Amendments to the Drawings:

REMARKS

This amendment is made in response to the FINAL Office Action mailed December 14, 2005. The amendment is accompanied by an RCE application. In this response, claims 14, 17, 21, 22 and 25 have been amended. Claims 15-16, 18-20 and 23-24 remain in this application. Claims 26-27 are newly added in this response.

FIG. 6

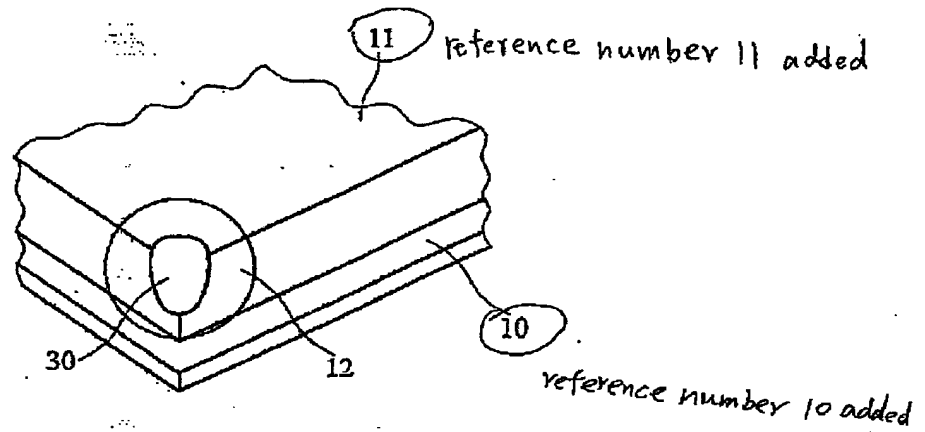
The attached sheet of drawings includes changes to Fig. 6, in which reference numbers 10 and 11 are added. This sheet, which includes Fig. 6-7, replaces the original sheet including Fig. 6-7.
